SUBJECT: SEABROOK STATION, UNIT 1 - STAFF ASSESSMENT OF INFORMATION PROVIDED PURSUANT TO TITLE 10 OF THE *CODE OF FEDERAL REGULATIONS* PART 50, SECTION 50.54(f), SEISMIC HAZARD REEVALUATIONS FOR RECOMMENDATION 2.1 OF THE NEAR-TERM TASK FORCE REVIEW OF INSIGHTS FROM THE FUKUSHIMA DAI-ICHI ACCIDENT (TAC NO. MF3921)

STAFF ASSESSMENT BY THE OFFICE OF NUCLEAR REACTOR REGULATION

RELATED TO SEISMIC HAZARD AND SCREENING REPORT

SEABROOK STATION, UNIT 1

Figure 3.2-1 Plot Comparing the Staff's and the Licensee's Mean Control Point Hazard Curves at a Variety of Frequencies at the Seabrook site

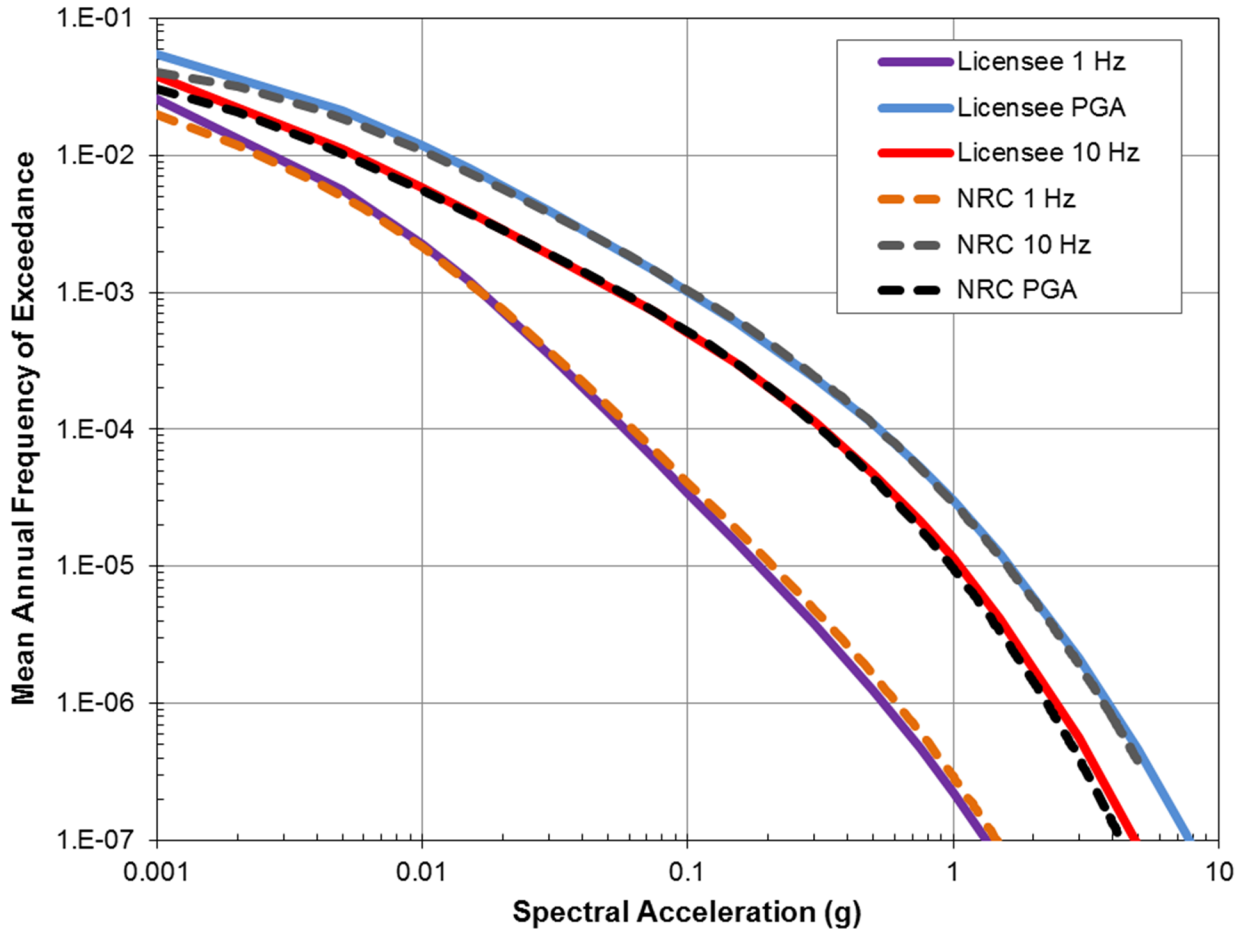
Based on its review of the SHSR, the NRC staff concludes that the licensee appropriately followed the guidance provided in the SPID for selecting the PSHA input models and parameters for the site. This includes the licensee's use and implementation of the CEUS-SSC model and the updated EPRI GMM model. The NRC staff's and licensee's control point rock seismic hazard curves are compared in Figure 3.2-1 of this assessment and show no appreciable differences.

Figure 3.4-1 Comparison of the Staff's GMRS with Licensee's GMRS and the SSE for the Seabrook site

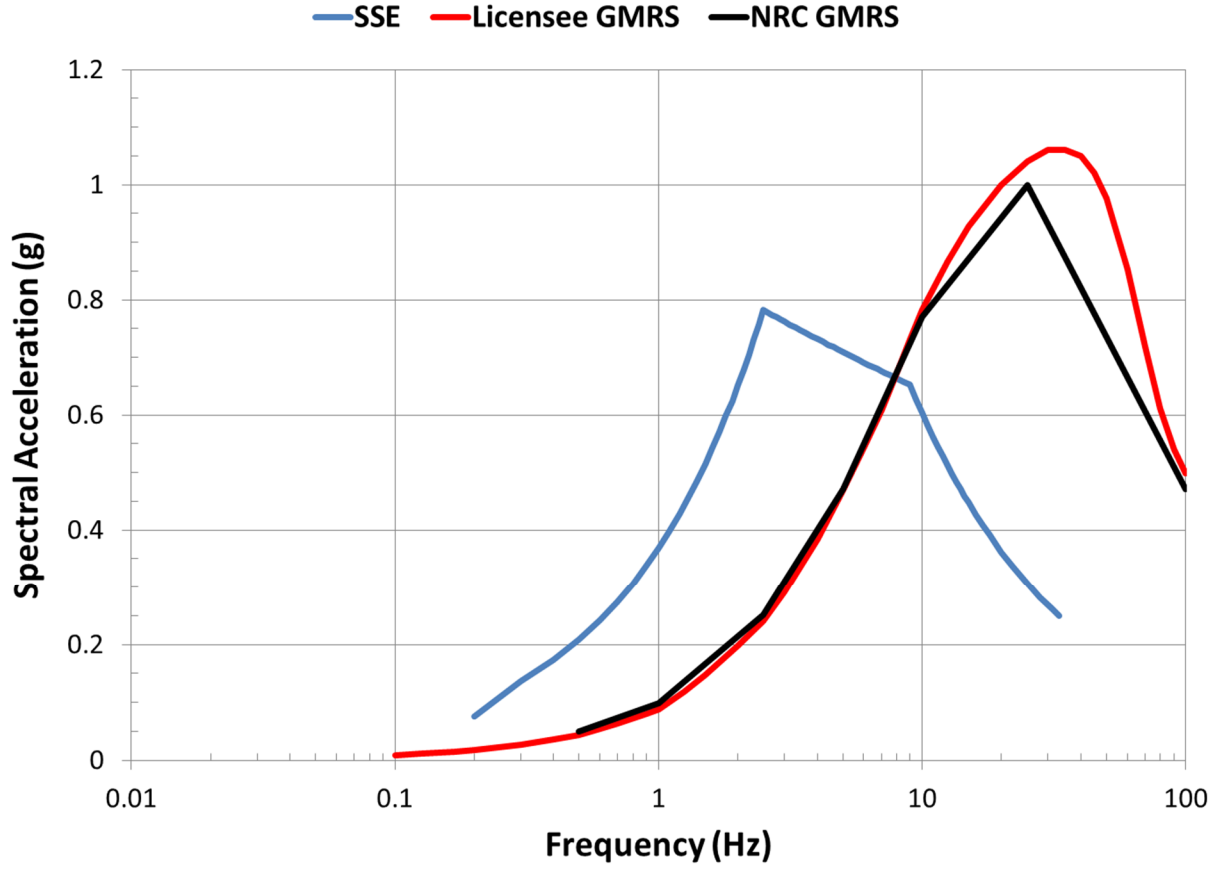
The NRC staff independently calculated the 10^{-4} and 10^{-5} UHRS using the results of its confirmatory PSHA, as described in Sections 3.2 and 3.3 of this staff assessment. Figure 3.4-1 of this assessment shows a comparison of the GMRS determined by the licensee to that determined by the staff. As shown in Figure 3.4-1, the licensee's and NRC staff's GMRS is similar to that calculated by the NRC staff. The difference in spectral accelerations at 25 Hz is only 4 percent. The difference between the staff's and licensee's GMRS above 10 Hz is primarily due to differences in interpolation between calculated spectral accelerations. The NRC staff concludes that these differences are acceptable for this application because the licensee followed the guidance provided in the SPID for the Seabrook site. The SPID provides guidance that is neither fully prescriptive nor comprehensive. As such, various approaches in performing analyses are acceptable for this application.

The NRC staff confirms that the licensee used the present-day guidance and methodology outlined in RG 1.208 and the SPID to calculate the horizontal GMRS, as requested in the 50.54(f) letter. The staff performed a PSHA confirmatory analysis and achieved results consistent with the licensee's horizontal GMRS. As such, the NRC staff concludes that the GMRS determined by the licensee adequately characterizes the reevaluated hazard for the Seabrook site. Therefore, this GMRS is suitable for use in subsequent evaluations and confirmations, as needed, for the response to the 50.54(f) letter.
